Notification of Product/Process Change

Title of change	Wafer Diameter Change, Wafer Process Production Site Change for 3rd Generation SiC MOSFET (TO247N Package) SCT3****L Series [PCN No.2222002]	
Affected product(s)	Manufacturer part number	Customer part number
	SCT3□□□□LGC11/SCT3□□□□LHRC11	
Detailed description of change	Now	After
	・On-board SiC chip's wafer diameter:4inch ・Front-end manufacturing plants : ROHM Apollo Co., Ltd. Chikugo Plant	・On-board SiC chip's wafer diameter:6inch ・Front-end manufacturing plants : Lapis Semiconductor Co., Ltd. Miyazaki Plant
Reason for change	To expand production capacity.	
Anticipated impact on quality	There is no difference in reliability and electrical characteristics.	
Identification of change	It can be identified by Lot number.

Document ID:2222002_PCN Details

PCN No.2222002

■ SiC wafer thickness after Grind

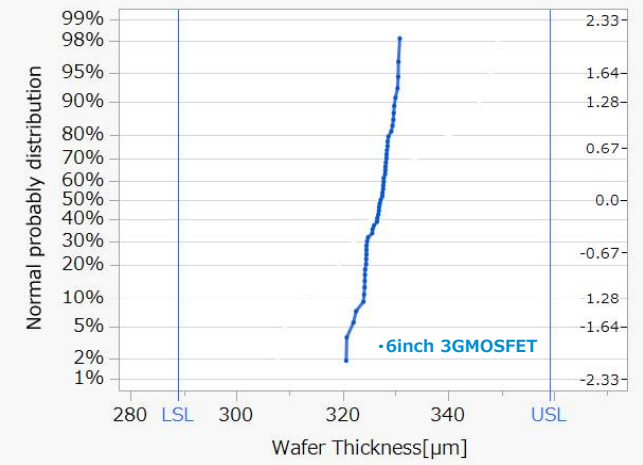
Wafer	6inch
Average	326.7µm
σ	2.5µm

We confirmed that there is no problem with the process capability of the grinding process(new process).

Zero Gate voltage Drain current [I_{DSS}]

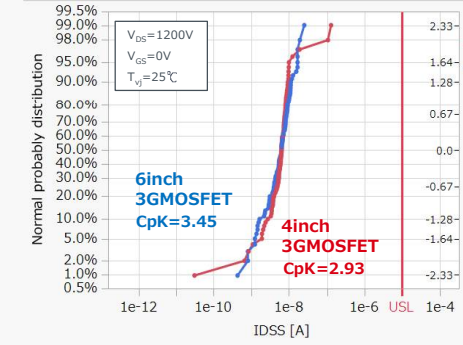
Wafer	N[pcs]	Ave[μA]	max[μA]	min[μA]	σ[μA]
4inch	100	0.00843	0.13011	0.00003	0.00679
6inch	100	0.00673	0.02534	0.00043	0.00430

Gate-Source leakage current [I_{GSS}(V_{GS}=22V)]

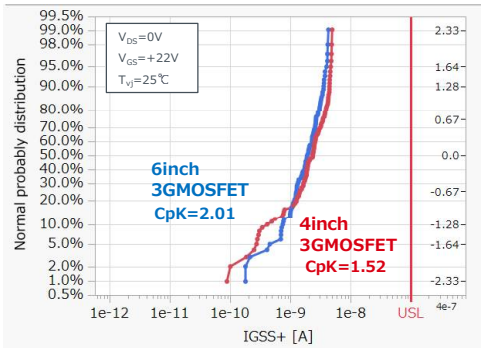
Wafer	N[pcs]	Ave[nA]	max[nA]	min[nA]	σ[nA]
4inch	100	2.394	4.919	0.087	1.353
6inch	100	2.031	4.263	0.178	1.006

Gate-Source leakage current [I_{GSS}(V_{GS}=-4V)]

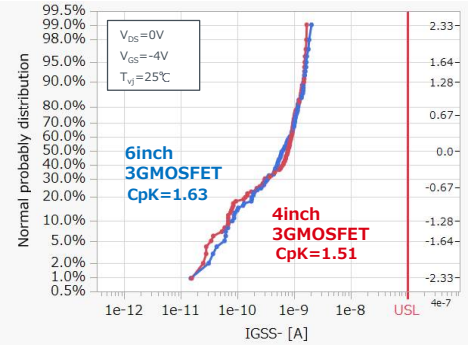
Wafer	N[pcs]	Ave[nA]	max[nA]	min[nA]	σ[nA]
4inch	100	0.716	1.658	0.016	0.486
6inch	100	0.713	2.015	0.015	0.512

Gate threshold voltage [$V_{GS(th)}$]

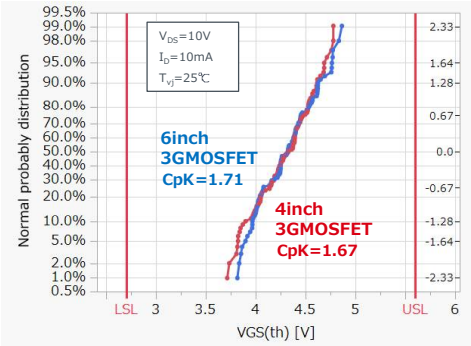
Wafer	N[pcs]	Ave[V]	max[V]	min[V]	σ[V]
4inch	100	4.30	4.78	3.72	0.26
6inch	100	4.31	4.87	3.82	0.25

Static Drain-Source on-state resistance [$R_{DS(on)}$]

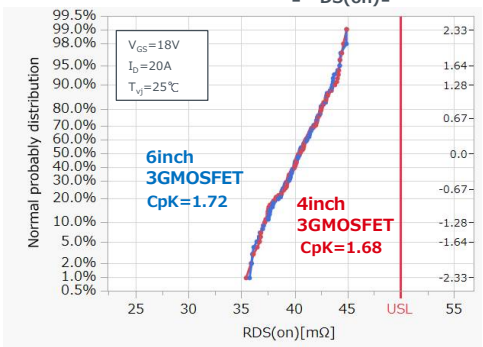
Wafer	N[pcs]	Ave[mΩ]	max[mΩ]	min[mΩ]	σ[mΩ]
4inch	100	40.46	44.92	35.43	2.29
6inch	100	40.45	44.88	35.76	2.24

Forward voltage [V_{SD}]

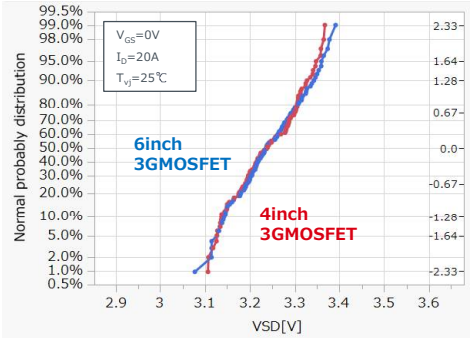
Wafer	N[pcs]	Ave[V]	max[V]	min[V]	σ[V]
4inch	100	3.24	3.27	3.11	0.07
6inch	100	3.24	3.39	3.08	0.07

■ Cross sectional observation of Non-defective samples after TC 1000cyc

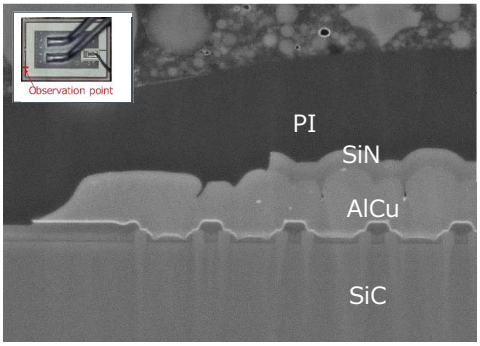
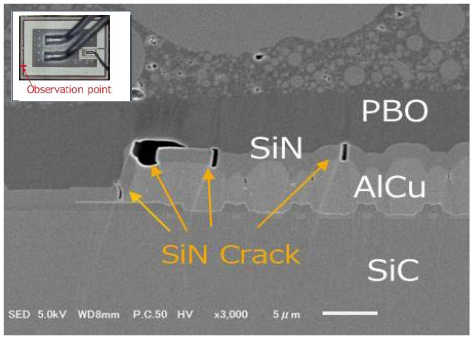
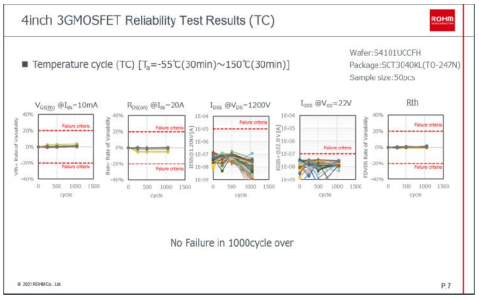
In 4inch 3GMOSFET, SiN layer in outer peripheral area may be cracked due to thermal stress such as temperature cycles. However, at the time of the TC 1050 cycle, the cracks are minor and there are no changes in characteristics, so there is no problem.

Structural changes have improved robustness against the cracking of the passivation layer(SiN).
